**WHITE LAKE TOWNSHIP
PLANNING COMMISSION**
7525 Highland Road
White Lake, MI 48383
APRIL 15, 2021 @ 7:00 p.m.
Electronic Meeting

RE: Lake Pointe – Final Site Plan and Final Engineering Plan – 3rd Review

Subject: Lake Pointe
Final Site Plan Review #1 based on plans dated February 2, 2021

SHEET 4

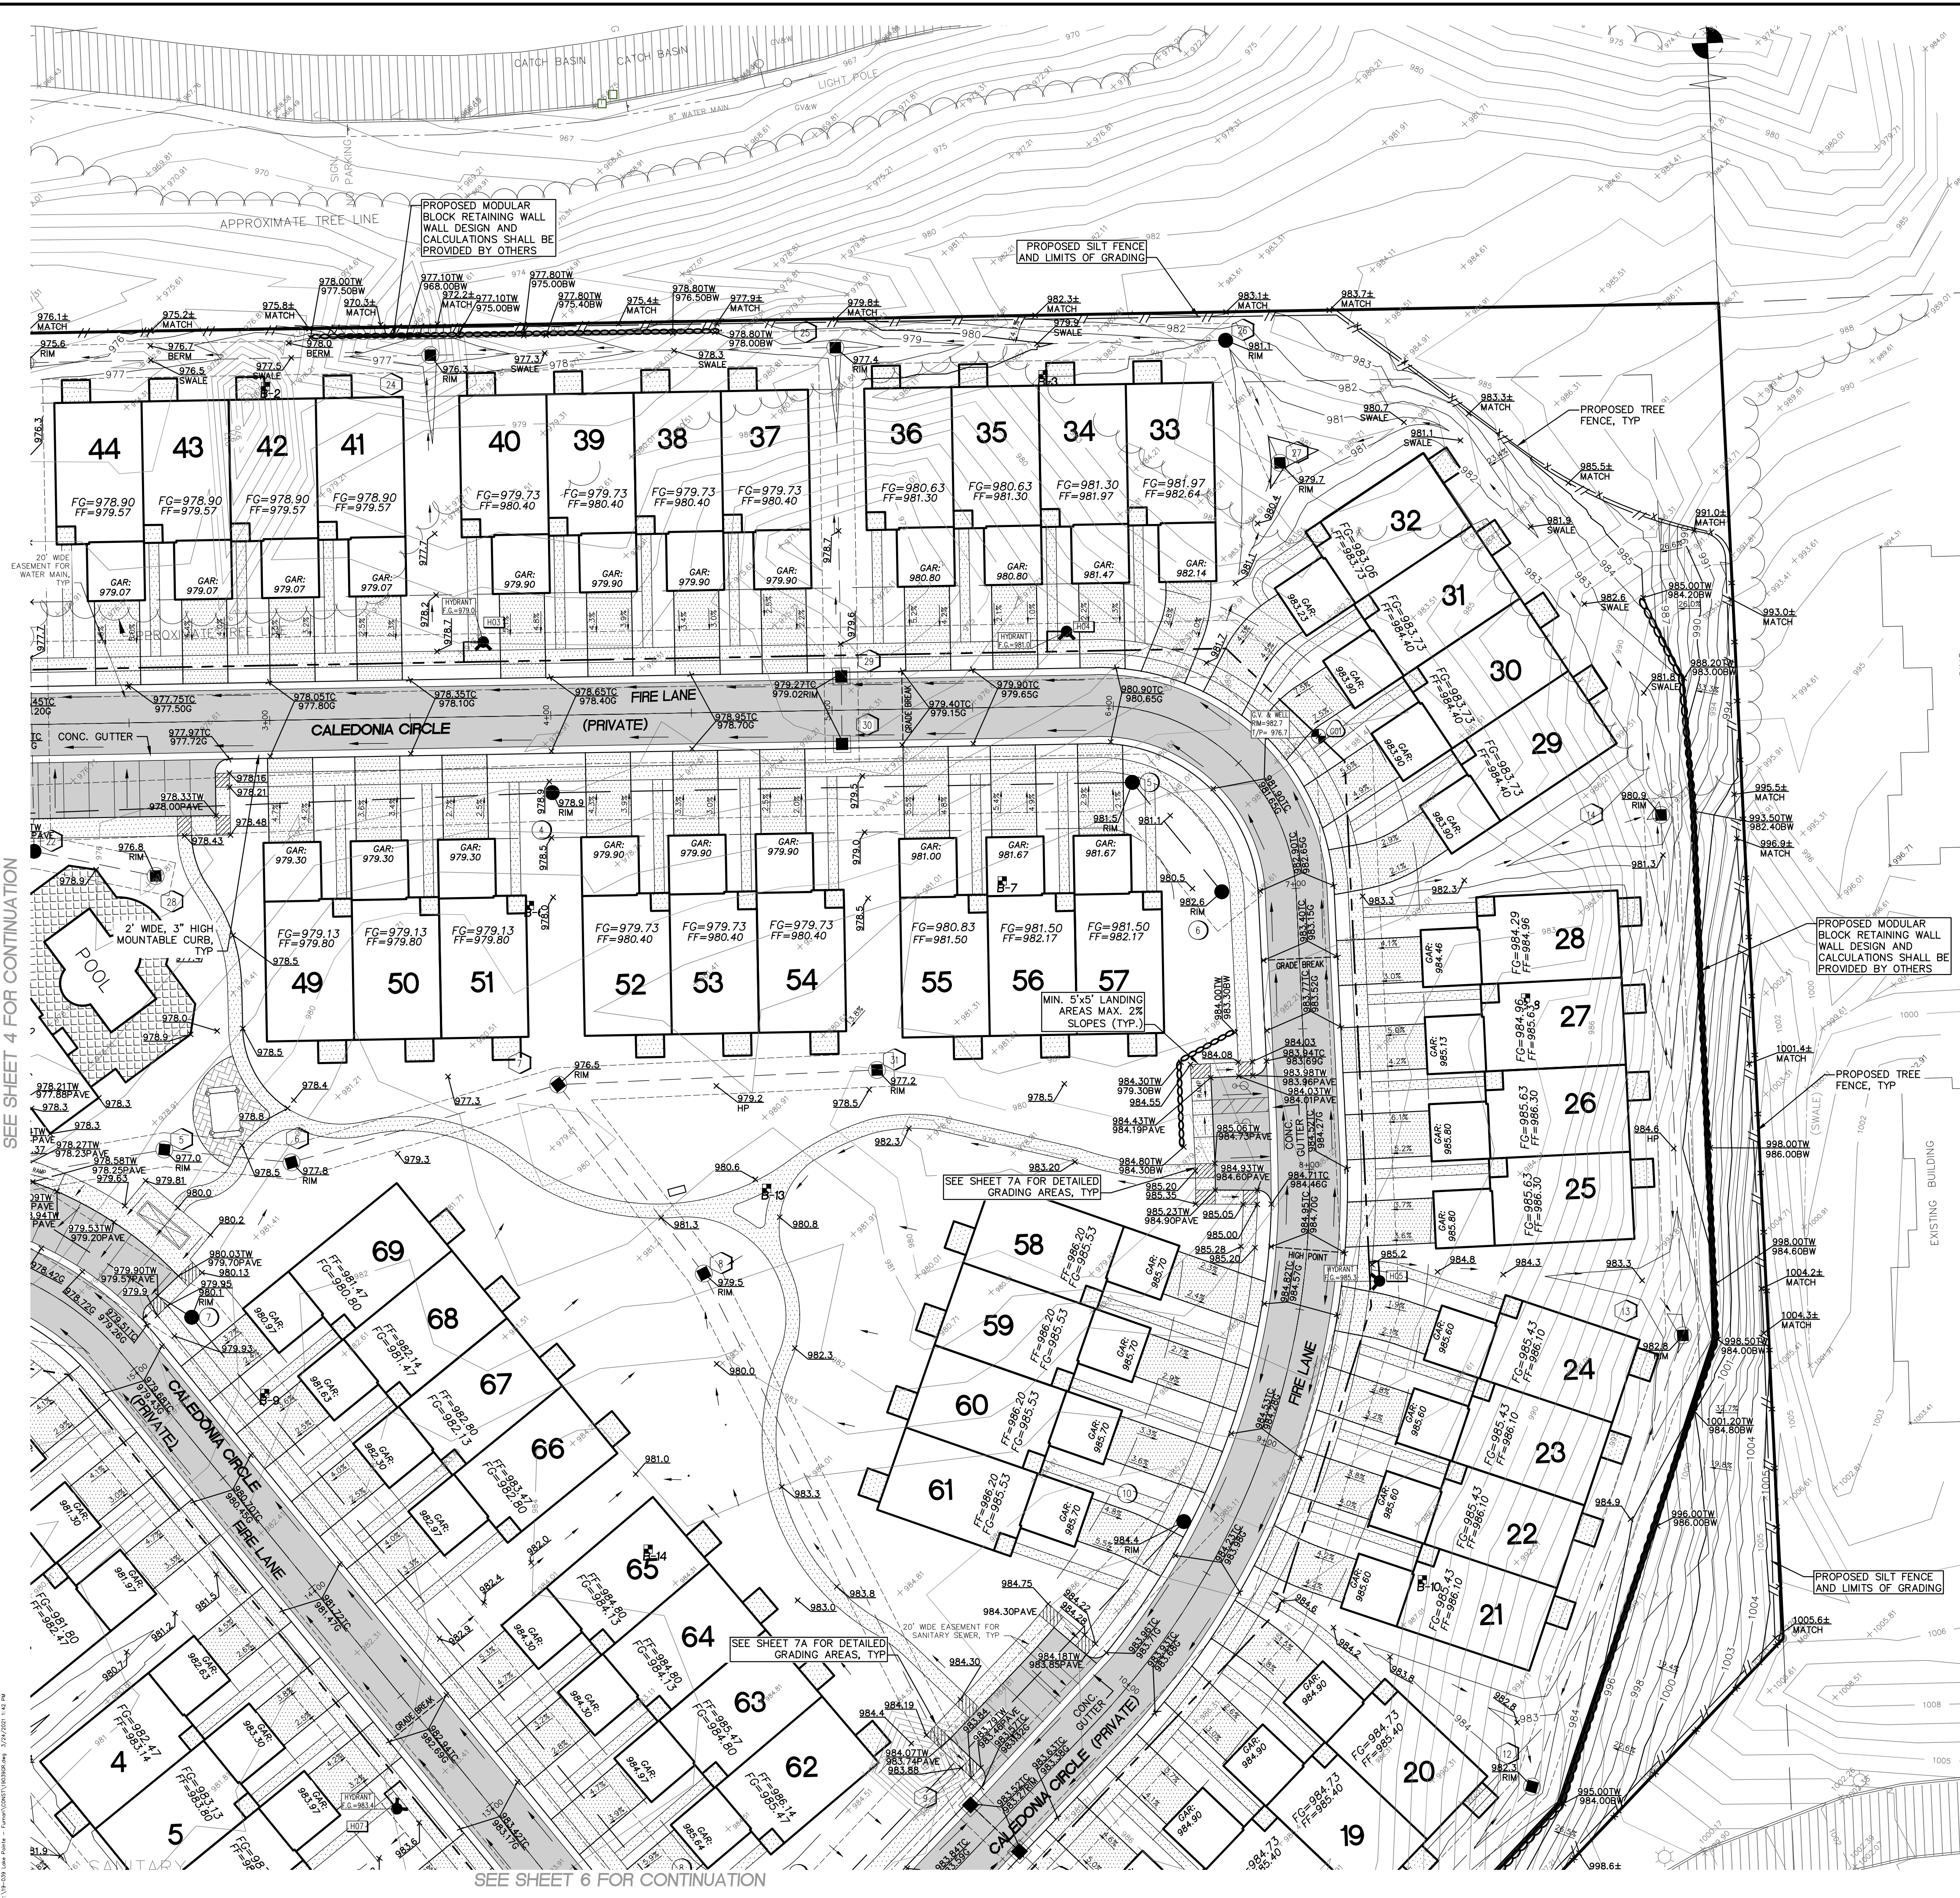
- 2. Sheets 4 and 6- There are several areas where proposed grades in the berm areas exceed the maximum allowable 1:3 slope requirement. Please revise these areas to meet ordinance requirements. Comment partially addressed. All areas requested were adjusted to meet ordinance requirements. However, please adjust berm slope of 35.7% that has been newly shown (Sheet 5- Eastern side of property) on the plan to < 33.3%. **Comment addressed.***

SHEET 15

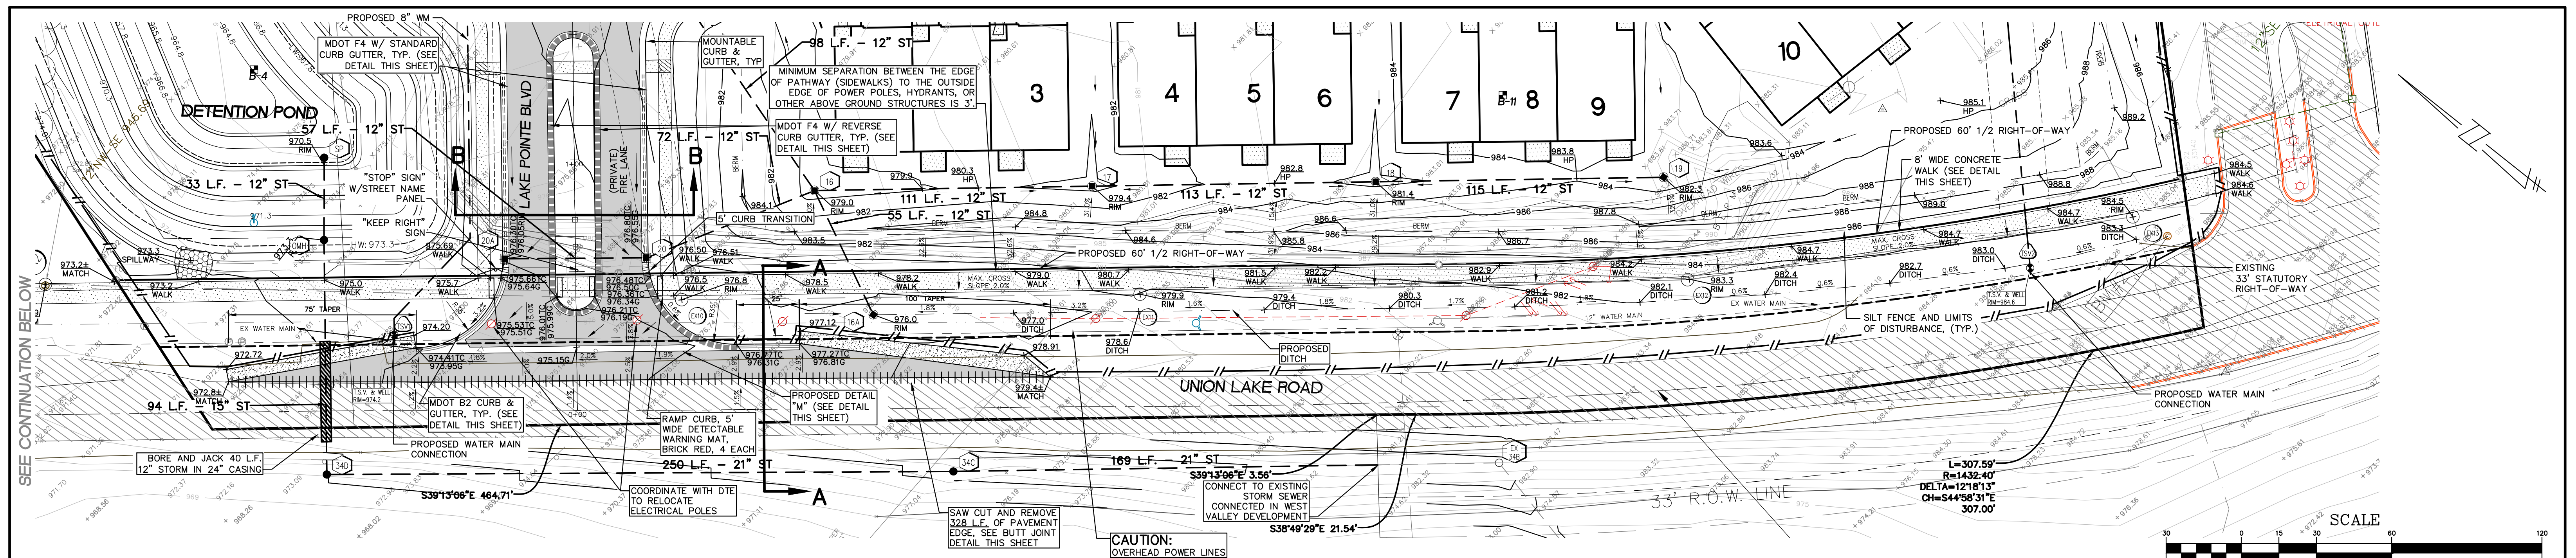
14. *Sheet 15- There are several additional items which will require revision. We have attached a marked up plan sheet for your use. Comment addressed. The items requested have been revised. However, some updates and revisions did not carry over to some plan sheets. Please revise the following: 1) Sheet 4- SP and OMH rims will need to match Detention Basin Restricted Outlet Profile View on Sheet 15. 2) Sheet 15-The Detention Basin Restricted Outlet Profile View will need to show the correct orifice diameter opening of 6” instead of 6.3”. **Comment addressed.***
